Item ID: D206-642-541

Item Name: Replacement Skidtube

DRAWING NO. D3274	TITLE SKIDTUBE ASSEMBLY	REV. D	DART AEROSPACE USA, INC ENGINEERING ORDER		D.E.O. NO. D3274-D-1	SHEET NO. SHEET 1 OF 1	SCALE NTS
DRAWN UP	CHECKED	MFG. APPR.	APPROVED		DE APPR.		
DATE 09.06.17	DATE 09.06.23	DATE 09/06/23	DATE 09/06/23		DATE 09.06.23

### DETAIL F: END FINISHING DETAIL

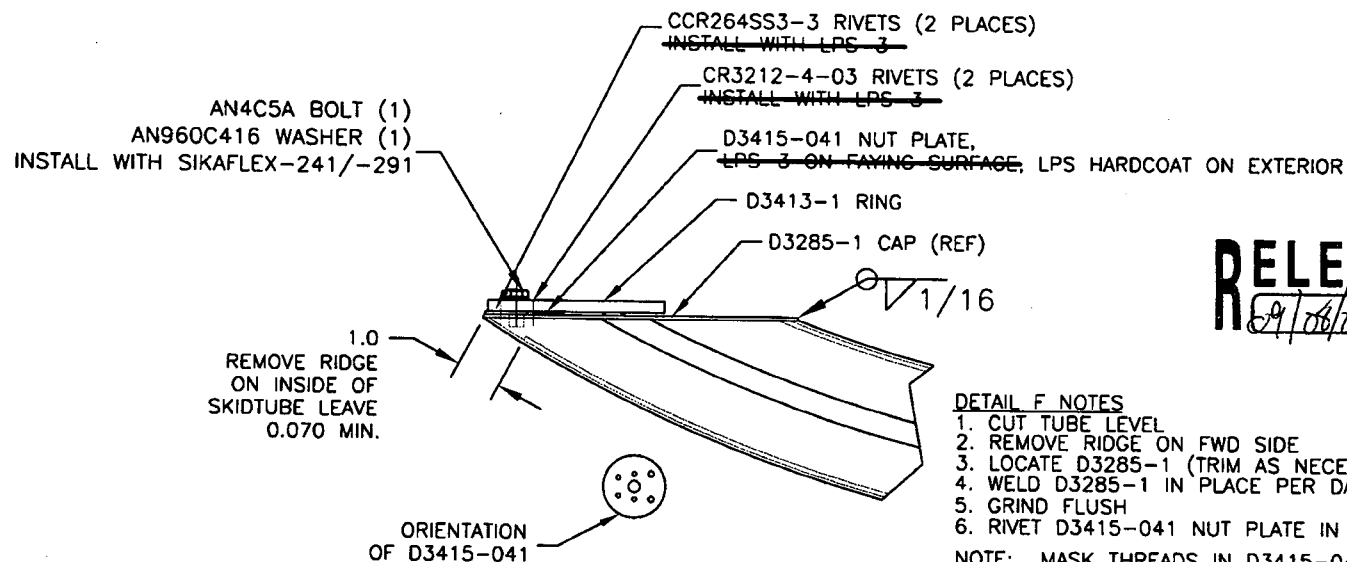
LPS-3 IS NO LONGER USED DURING ASSEMBLY OF SKIDTUBE.

AMEND DETAIL F AS SHOWN:

1. CUT TUBE LEVEL
2. REMOVE RIDGE ON FWD SIDE
3. LOCATE D3285-1 (TRIM AS NECESSARY)
4. WELD D3285-1 IN PLACE PER DART QSI 004
5. GRIND FLUSH
6. RIVET D3415-041 NUT PLATE IN PLACE
